**Subject: Additional Information – Westlink Industrial Estate Stage 2 (SSD-46983729)**

**CPHR advice – Additional Information – Westlink Industrial Estate Stage 2 (SSD-46983729)**Documents Reviewed

Figure 1: CPCP Spatial Viewer showing locations of excluded land in yellow.

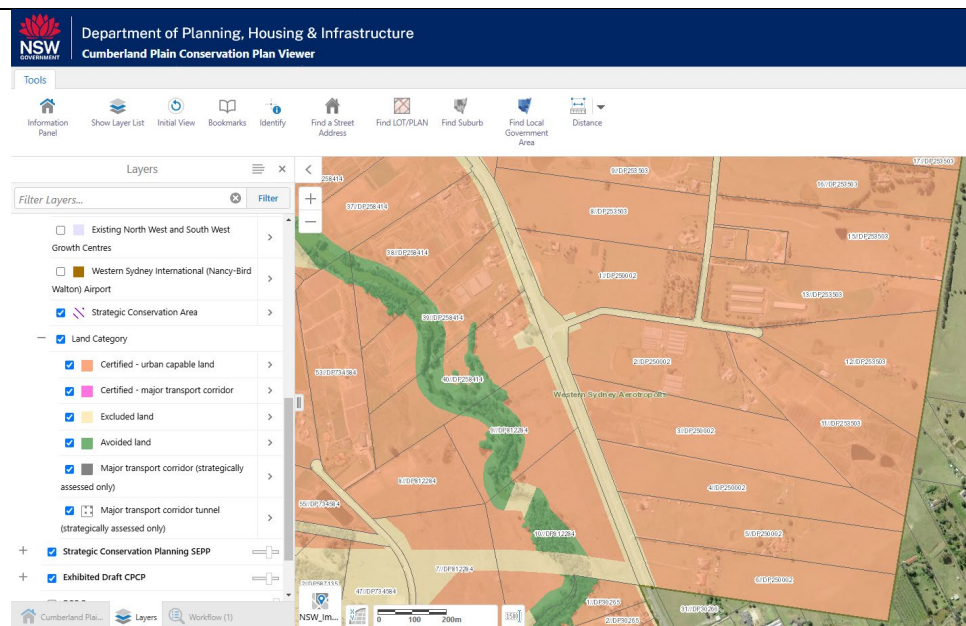
1.	<i>Works on excluded land</i>	<p>CPHR highlights that the previous advice (dated 16 October 2024, ref: DOC24/785209) regarding the portion of 'excluded land' under the CPCP has not been addressed in the additional information provided.</p> <p>CPHR reiterates that the Department must be satisfied that no works are proposed in excluded land, as section 7.9 of the <i>Biodiversity Conservation Act 2016</i> applies to any works on excluded land.</p> <p>The Mamre Road Development Control Plan (DCP) Compliance Table under 2.2.2 (2) Biodiversity Certification states, 'The Site has been certified as 'urban capable land' under the CPCP from 17 August 2022. An assessment of the likely impact on biodiversity of development on biodiversity certified land is not required for the purposes of Part 4 of the EP&amp;A Act.'</p> <p>However, as shown in the CPCP Spatial Viewer below (refer to Figure 1), there is a portion of excluded land along the Mamre Road roadside of both Lots 3 and 4.</p>

1. A plan be provided to clearly identify the location of works in relation to the CPCP excluded land to clearly demonstrate that there are no works proposed in the excluded land.
2. In the event works would be carried out in excluded land the following must be conducted prior to determination:
  - a. A Biodiversity Development Assessment Report (BDAR) be prepared and submitted to the Department, or a
  - b. BDAR waiver be submitted to CPHR for assessment. Should a BDAR waiver be sought, it must be clearly demonstrated that the proposed development is not likely to have any significant impact on biodiversity values. Development that requires clearing of native vegetation or additional biodiversity impacts as prescribed by clause 6.1 of the Biodiversity Conservation Regulation 2017 is likely to require a BDAR.
